WILLIAMSON COUNTY, TEXAS

CHANGE ORDER NUMBER: 14

Roadway: FM 3349

**FM3349 at US 79
Williamson County Project No. 22IFB139**

SHEET 35C

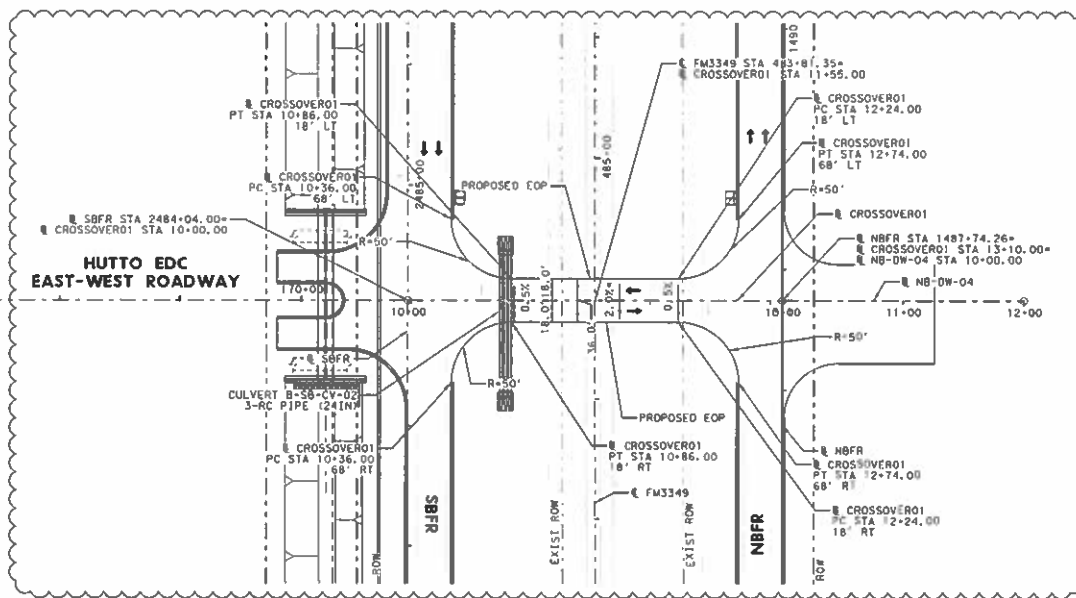
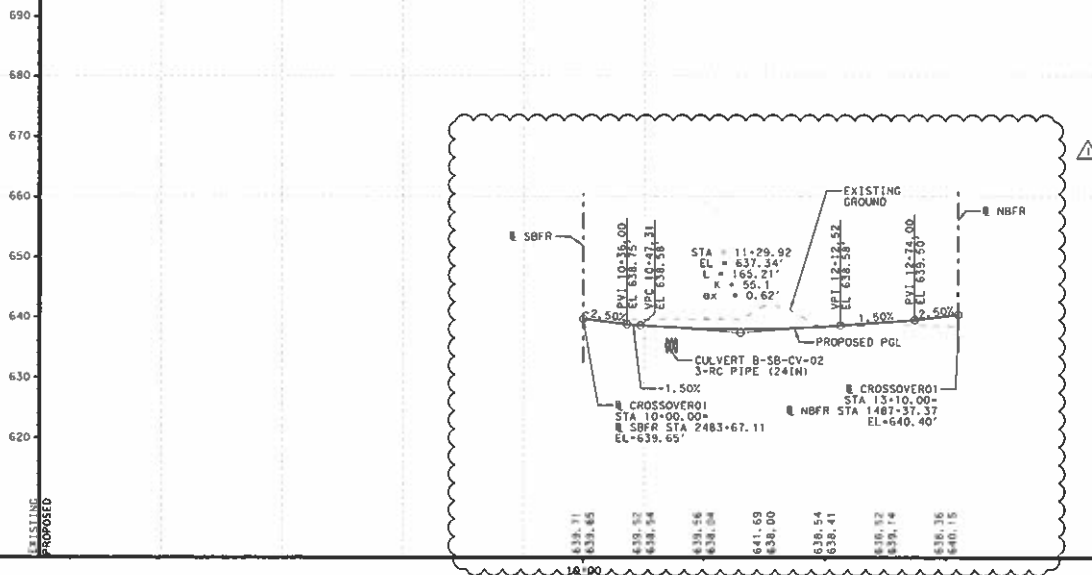
2C. New Development (Conditions Changing After PS&E Completed). This Change Order provides compensation to the Contractor for relocating box culvert No. 4 on the southbound frontage road, to accommodate the location of the new City of Hutto street (Spine Road). The culvert and crossover to FM 3349 were moved approximately 36 ft. to the north to align with the centerline of the Spine Road.
